KMR.CDD.SoQ.1932.02

NOTICE UNDER SECTION 96 (1) CHAPTER IX OF THE BOMBAY
DISTRICT MUNICIPAL ACT III OF 1901 AS MODIFIED
- UPTO THE 1st MARCH 1915.Karachi, 8th July 1932.

PLAN OF PROPOSED BUILDING ON PLOT

Case No. P/C 346 of 1932.

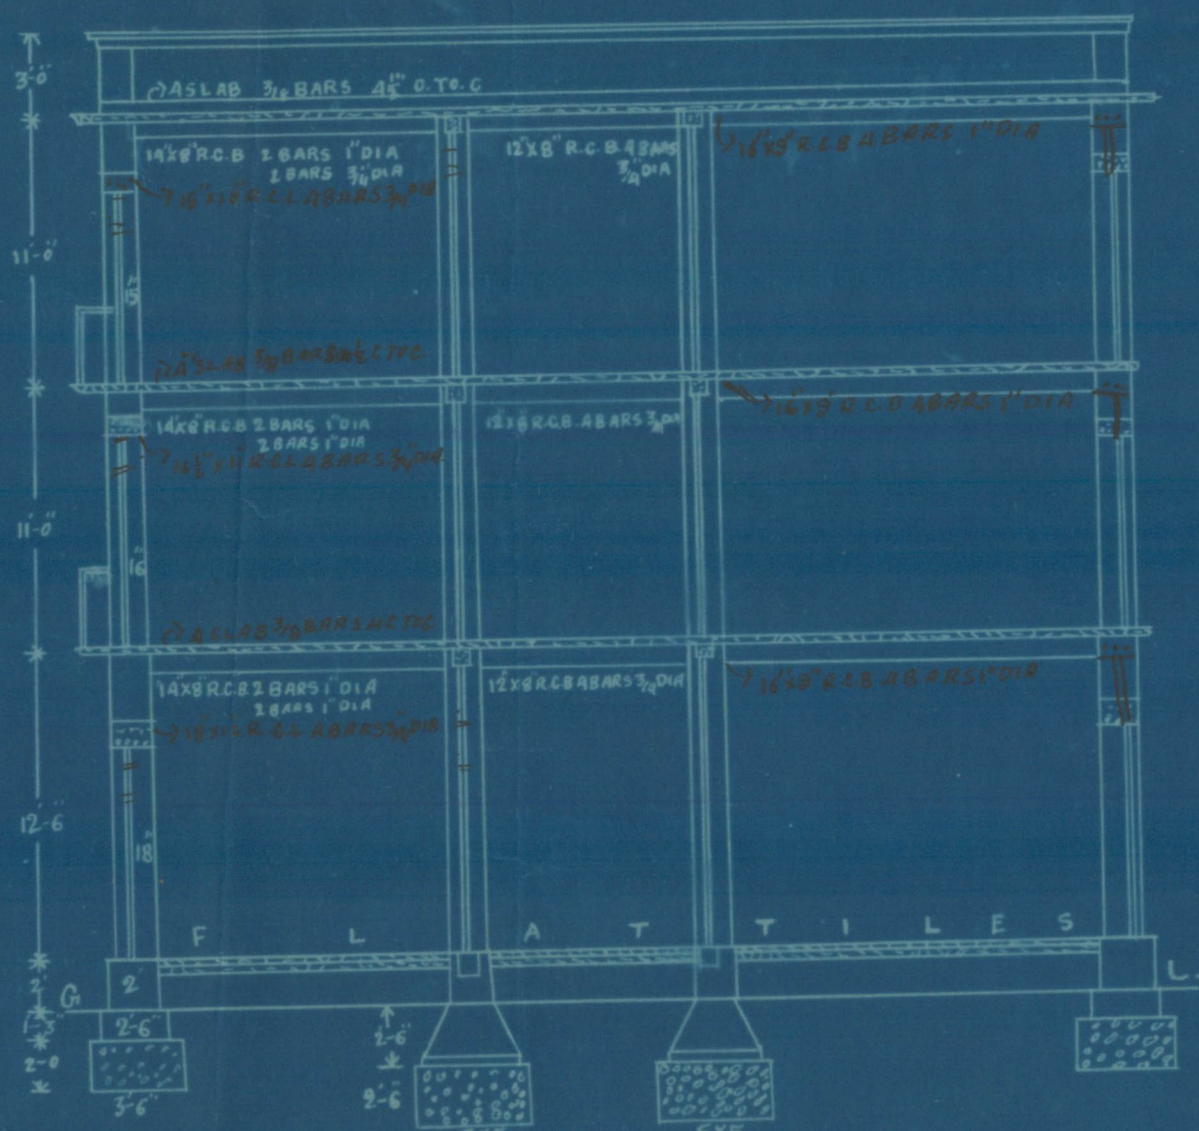
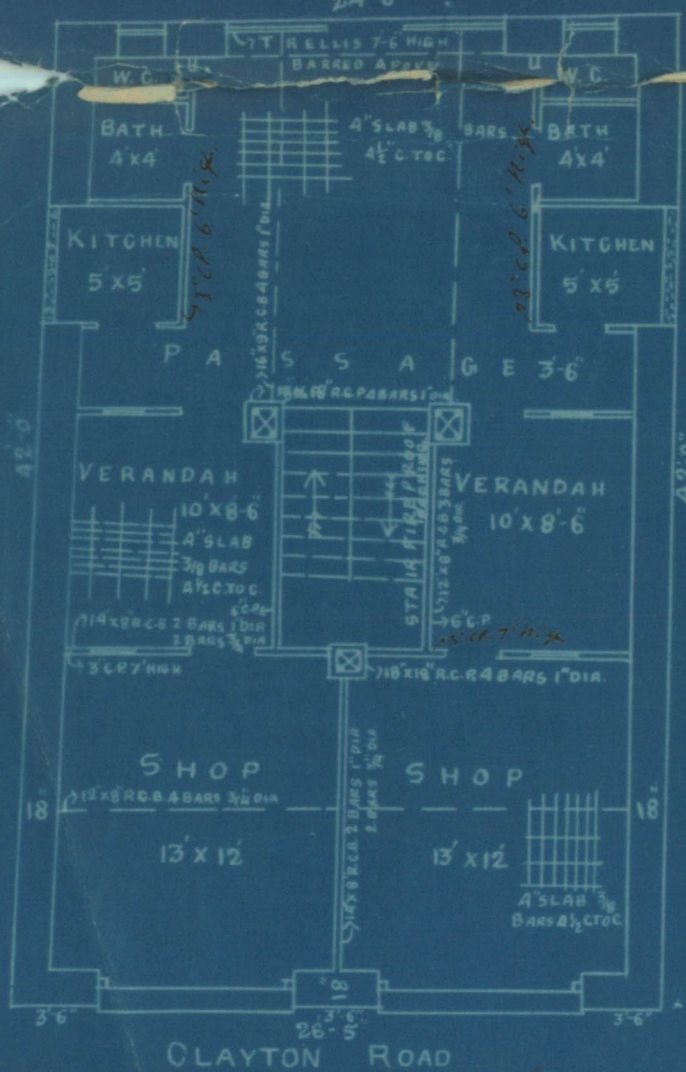
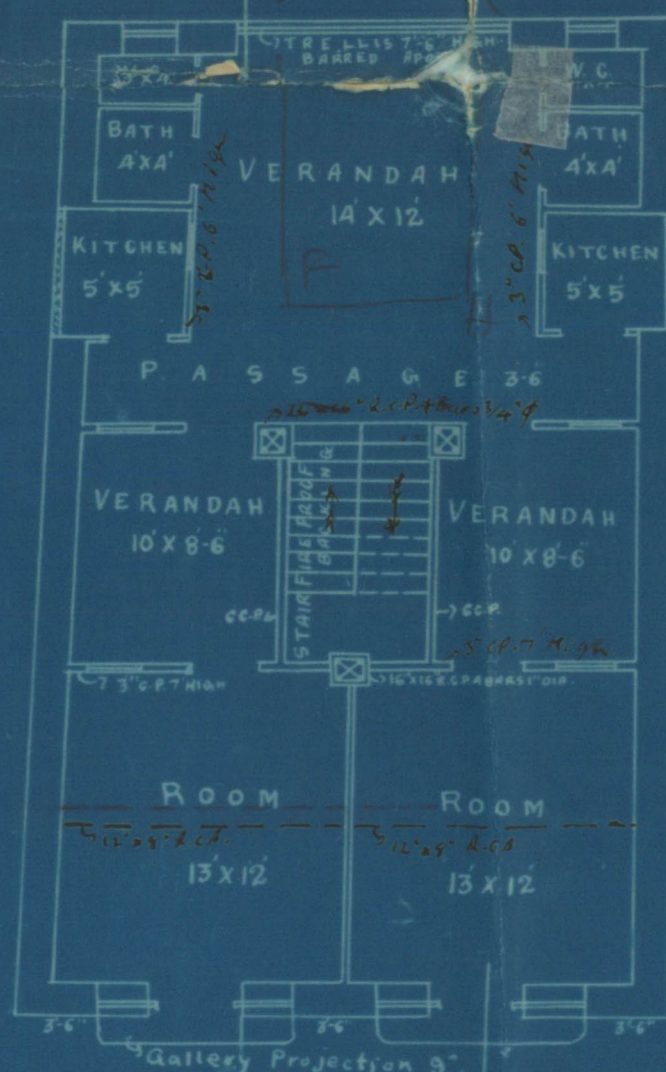
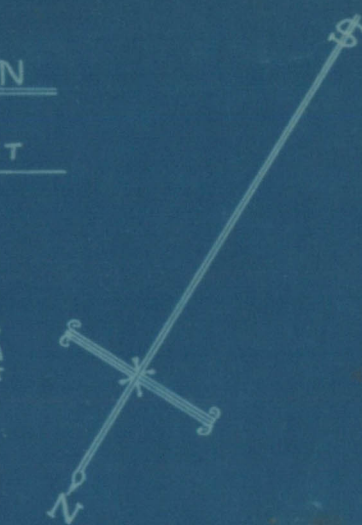
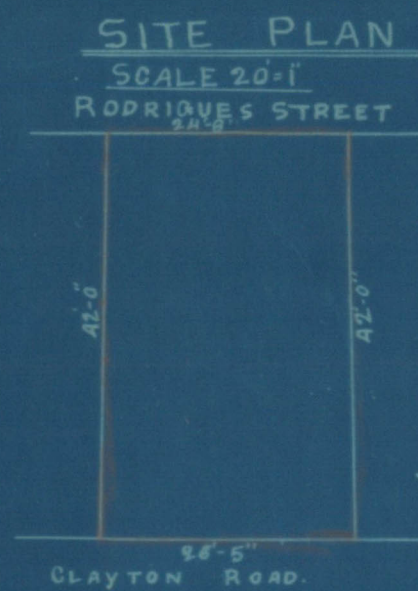
Alignment must be shown & left.
Measurements must be correct. and adjoining, &
the plan be given

- (1) Steps should be provided in the owner's own limit.
- (2) Inner Veranda will be dark.
- (3) Beams over Sanitary Conveniences must be shown.
- (4) Extra rods be provided under partitions.
- (5) Lintel over Kitchen should be shown.
- (6) Alignment of must be shown left.
- (7) Measurements must be corrected as adjoining of the plot be given.
- (8) E. F. & H. must be left open.
- (9)
- (10)
- (11)
- (12)

we have corrected the plans as required by
